Docket Item #16
BAR #2018-00531

BAR Meeting
December 19, 2018

ISSUE: Revisions to Previously Approved Plans

LOCATION: 822 South Pitt Street

Figure 1. Existing east (rear) elevation with red box showing area to be demolished

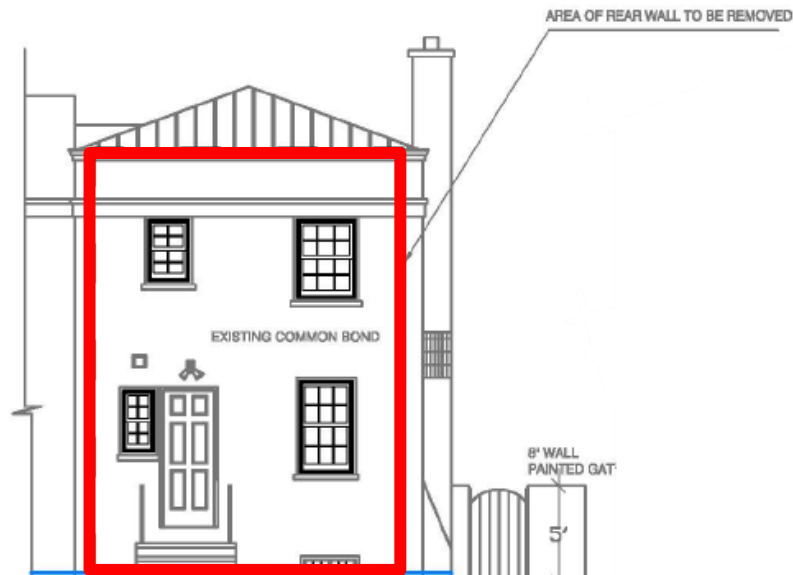
There are no proposed changes to the approved Permit to Demolish. Demolition will remain limited to the east (rear) wall as shown in Figure 1.

2
A-2 **PROPOSED WEST ELEVATION**
SCALE: 1/8" = 1'-0"

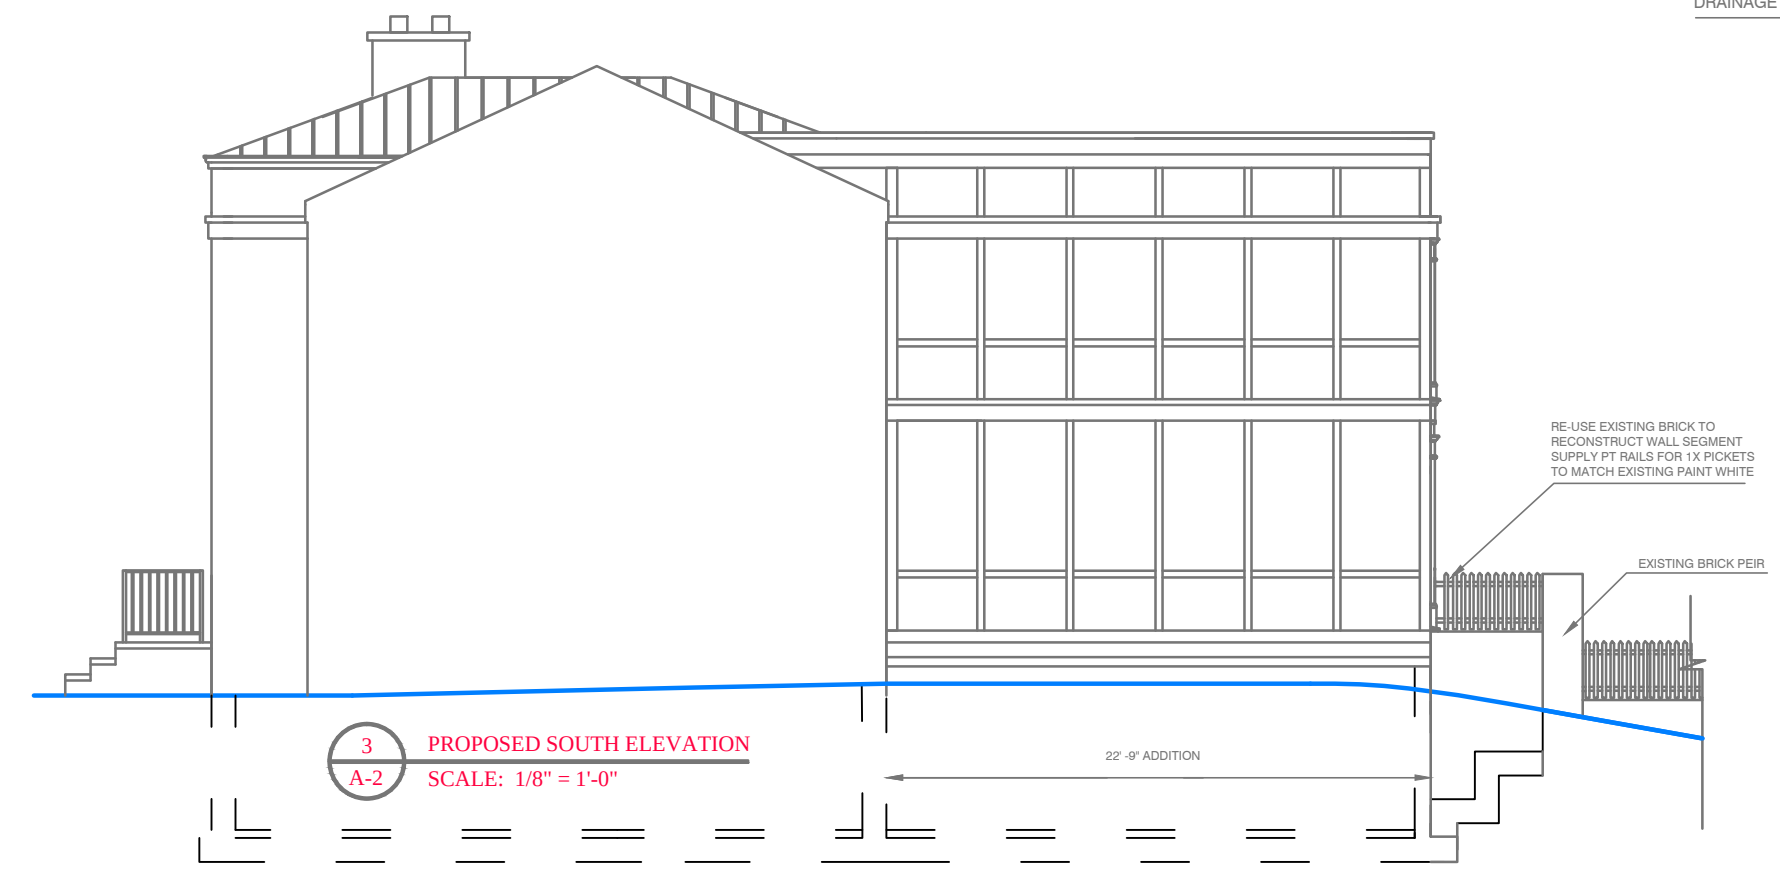
The previously approved plans did not include any changes to the façade and staff believes that retaining the original broken scroll pediment front door-surround preserves the historic design integrity of this simple building from the street. Changing the pediment to coordinate with the obliquely visible proposed addition is architecturally unnecessary and staff recommends retention of the existing door-surround.

1. Retain the existing original broken scroll pediment architrave at the front door.
2. Include the statements in archaeology conditions below in the General Notes of all site plans and on all site plan sheets that involve demolition or ground disturbance (including Basement/Foundation Plans, Demolition, Erosion and Sediment Control, Grading, Landscaping, Utilities, and Sheeting and Shoring) so that on-site contractors are aware of the requirements.
